MAYFLOWER PLATINUM

Details of Additions & Alterations

Flat No	108	Block no.	'A'
Flat Area	1800 sft	Type	Deluxe / Luxury
Buyer Name	A Mohan Ganesh/G.Sita Madhavi		
Phone No.	9849028941/9949469853(C), 040-48574237	Email	gsitamadhavi@gmail.com

Description	Direction	Owners & Developers :	Date :	18.03.2020	Promoted by
WORKING DRAWING OF FLAT.NO.A-8	N 	Modi Properties Pvt Ltd. Project Name & Phase :	Prepared By :

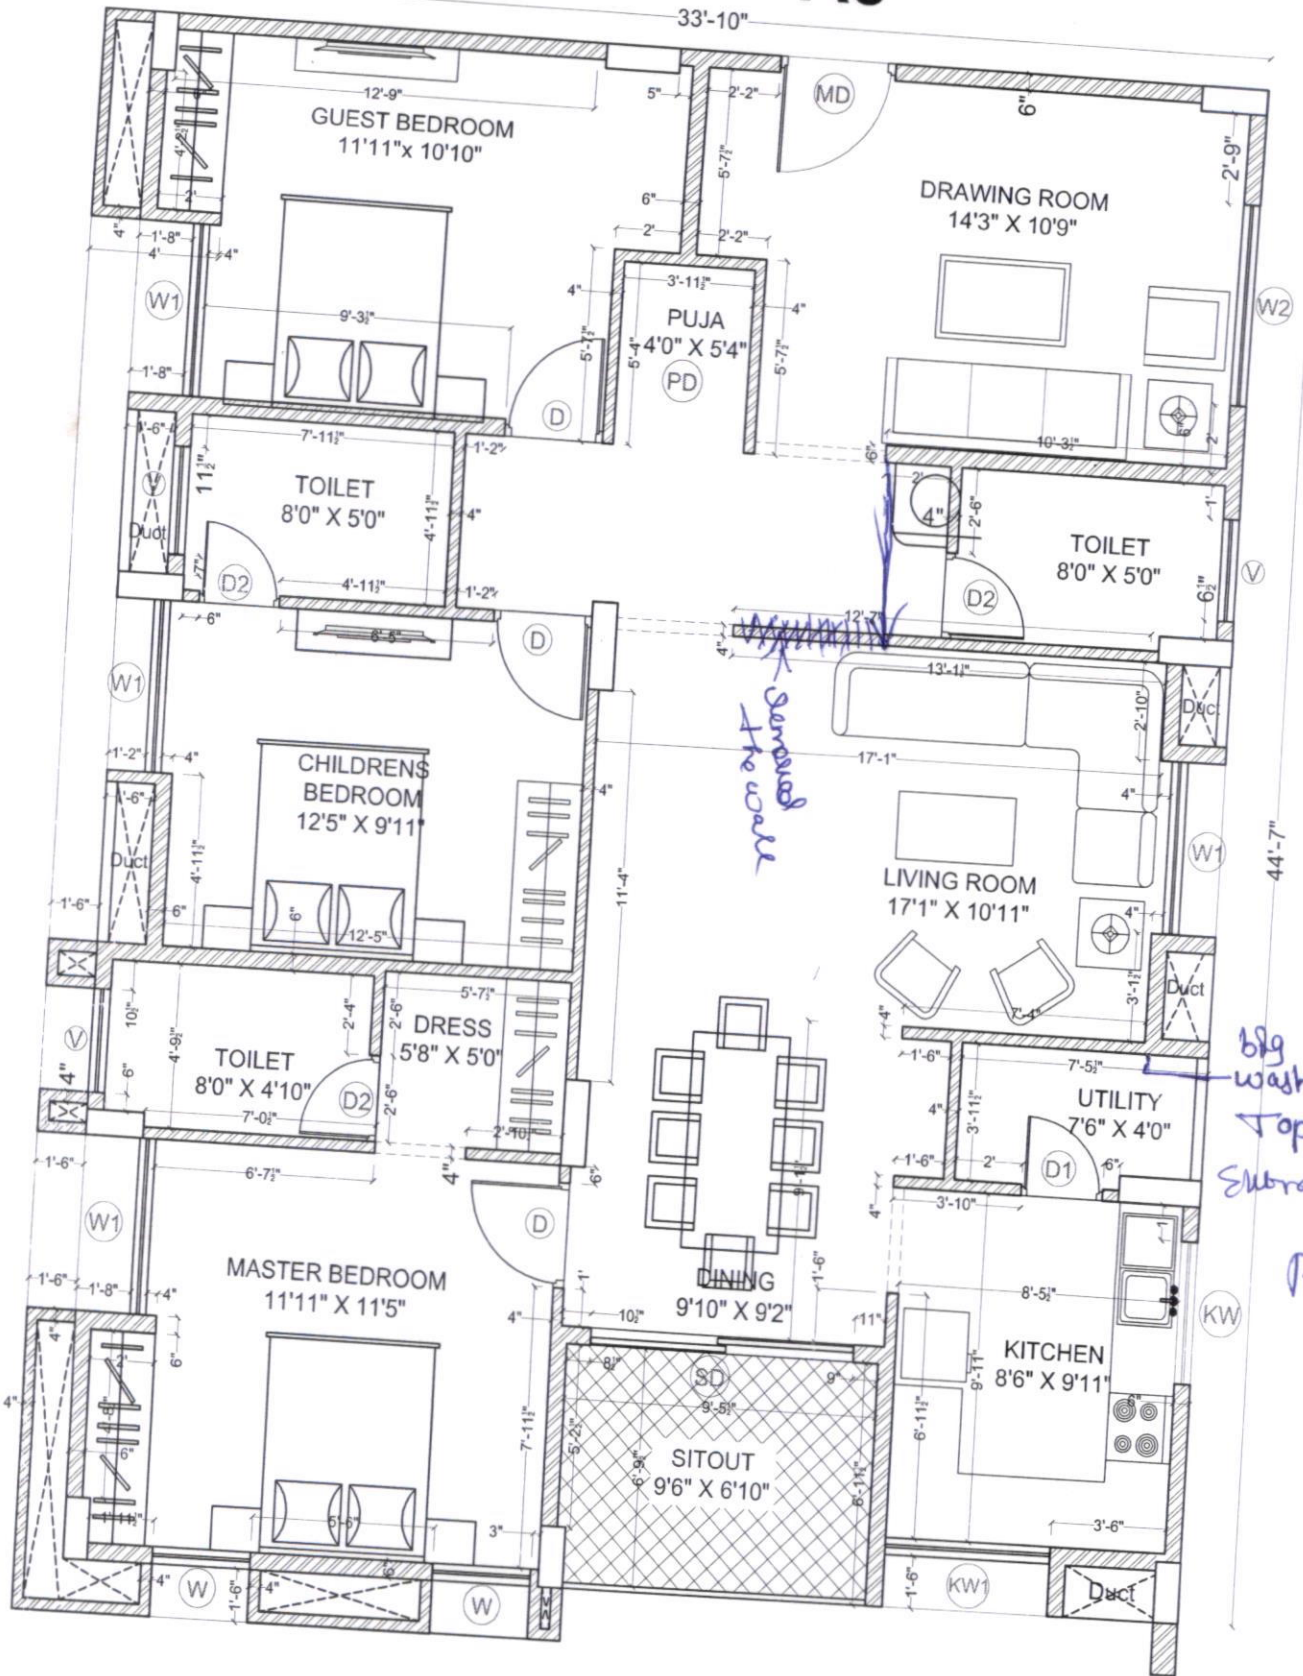
- ① ~~Common~~ wall removing at Drawing room wall same as living wall (marked as plan)
- ② all windows - 3 track with mesh.

ELECTRICAL PLAN OF FLAT-A8

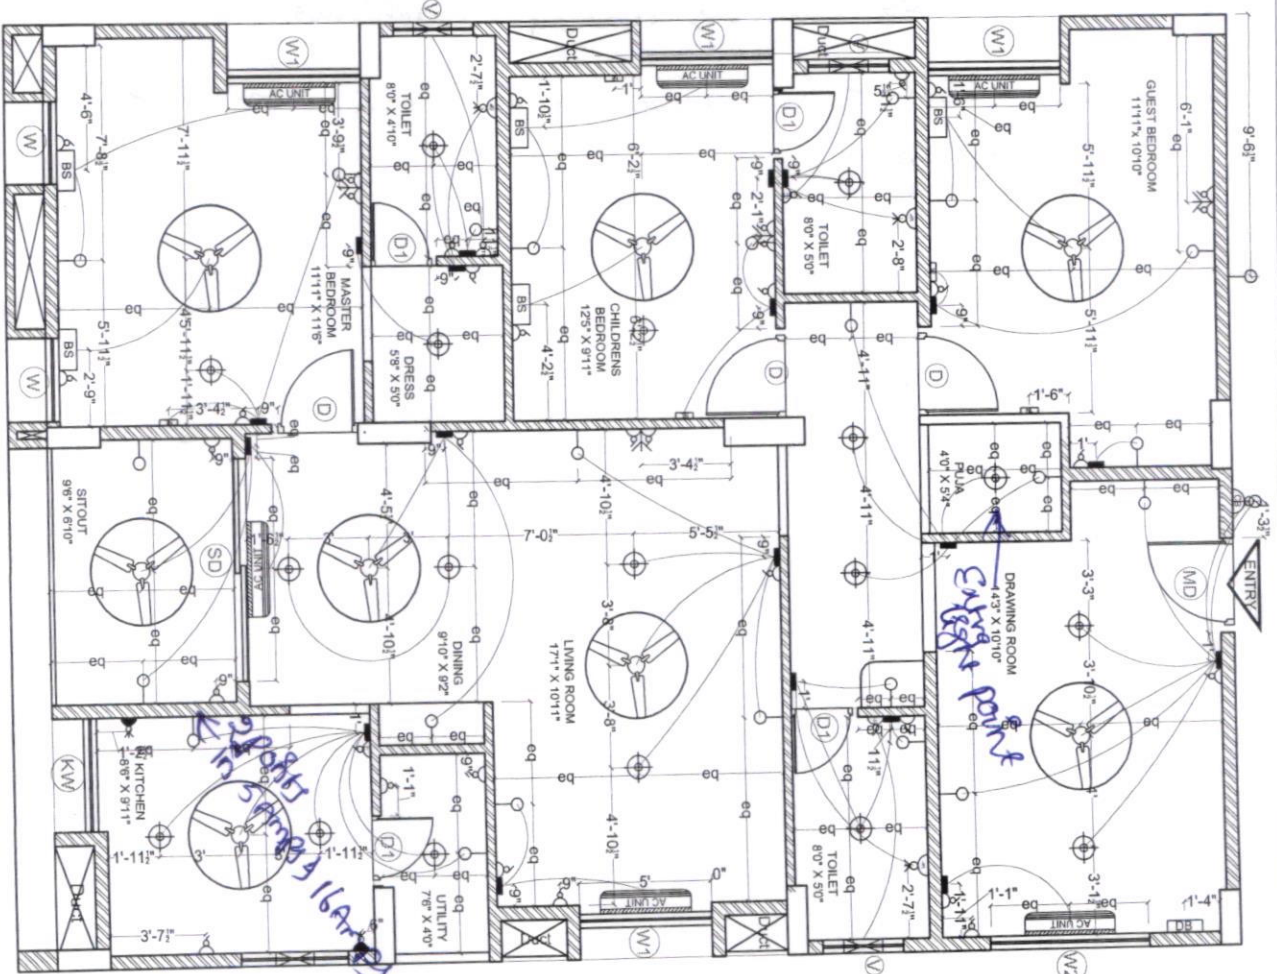
Extra in kitchen 2 points 5amp, 16amp
